**BEFORE THE BOARD OF PATENT APPEALS  
AND INTERFERENCES**

Application Number: 09/806,800  
Filing Date: June 25, 2001  
Appellant(s): SWANEPOEL, ADRIAAN RETIEF

**EXAMINER'S ANSWER**

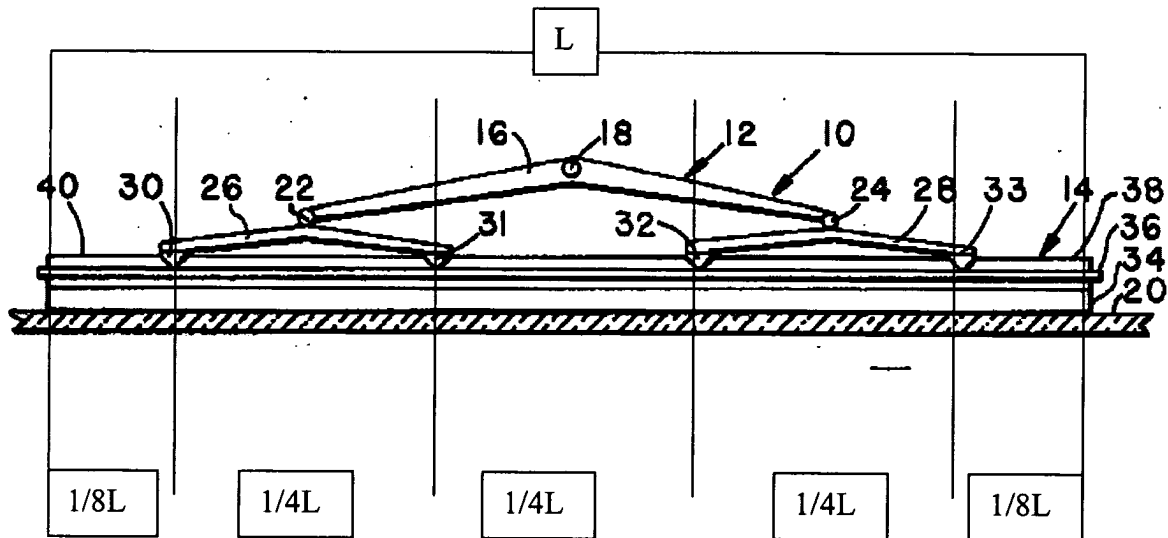
With regards to claims 1, 2, 13 and 14, Wittwer teaches a wiper comprising a force-applying member (12) connected to the center backbone at two spaced apart points (31, 32). The backbone or backing strip is a formed from a single, unitary, flexible material that is precurved or prebowed in a direction substantially parallel to the curvature of the windshield (col. 2, lines 57-59). Wittwer does not refer to the backbone as a beam, however, Thompson teaches a wiper blade with a beam (96; col. 10, lines 13-14) that could be used on a tournament style wiper (figure 8, col. 26-28). The beam of Thompson functions in the same manner as Wittwer and therefore, as evidenced by Thompson a beam and a backbone or backing strip are considered equivalent terms in the art. Wittwer teaches a superstructure with four pairs of equally spaced apart claws (30, 31, 32 and 33) that slidably engage with the backing strip or beam (36) by means of claws with pin type structure that engage around the outer exposed longitudinal slot edge portions of the flexible backing strip. The remote claws (30, 33) are at a location  $1/8$  the length of the wiper blade element in from the ends. The four points of pressure being applied to the backing strip or beam at equally spaced apart locations between the remote pressure points beneath the claws (30, 33). It can be determined that the spacing between the two points (31, 32) is  $1/4$  the length of the wiper blade and the ratio of spacing to the total length is  $1/4$  (see figure below), therefore,  $S=0.25*L$  and  $R=0.25$  which falls in the ranges claimed by the appellant.

With regards to claim 3, the preferred spacing distance  $S_p$  between the spaced apart points is *about*  $S_p=0.363*L-0.000146*L^2$ .

With regards to claim 4, the preferred ratio  $R_p$  is *about*  $R_p=0.363-0.000146*L$ .

With regards to claim 8, the curved backing strip or beam has a constant width along its length since the yokes do not change. The same clips are used to connect all four points on the backing strip or beam.

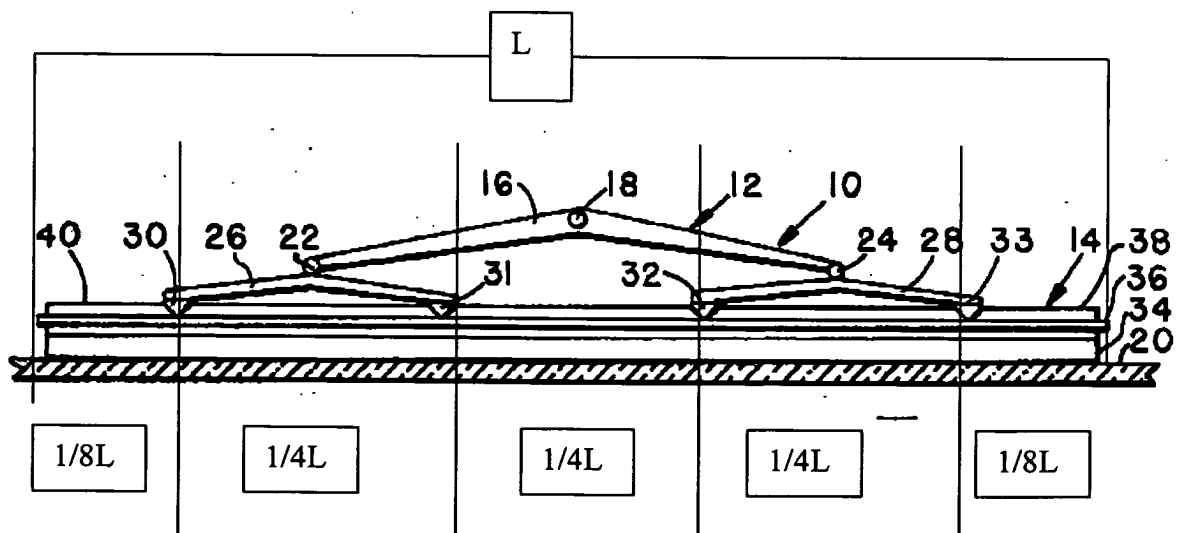
The appellant further argues that *a rejection based on measurements taken from the Wittwer et al. drawings is improper*. In response, the examiner is not relying on measurement

from the drawings to support the rejection of the claims. Instead, the reference clearly states that there are four pairs of "equally spaced" claws, wherein the remote claws are located spaced  $1/8$  the length of the blade in from the ends (column 2, lines 63-67 and column 3, lines 1-22). The examiner took these limitations and depicted them on the figure below for clarity. No measurements were made on the drawings to determine the distance between the claws with respect to the length. This information is directly from the reference. Therefore, since the ratios of length are known for each claw, it is easily determined that the appellant's claimed spacing distance  $S$  (distance between claws 31 and 32) is equal to  $.25L$  (no measurements needed) and appellant claimed ratio of spacing between points and total length ( $R=S/L$ ) is  $.25$ . With regards to claims 3 and 4, given that the ratios are known for the claw length, any arbitrary number and unit can be used for the length ( $L$ ) as long as the ratios remain the same. For example,  $L$  could equal 32, where  $S$  would equal 8 or  $L=12$  and  $S=4$ . If any of these numbers were entered in the equations for claims 3 and 4, it can be determined that the preferred spacing for Wittwer is *about*  $.35L$  (actual is  $.36L$ ) and preferred ratio for Wittwer is *about*  $.35$  (actual is  $.36$ ) which fall within the accepted claim range in claims 1 and 2.
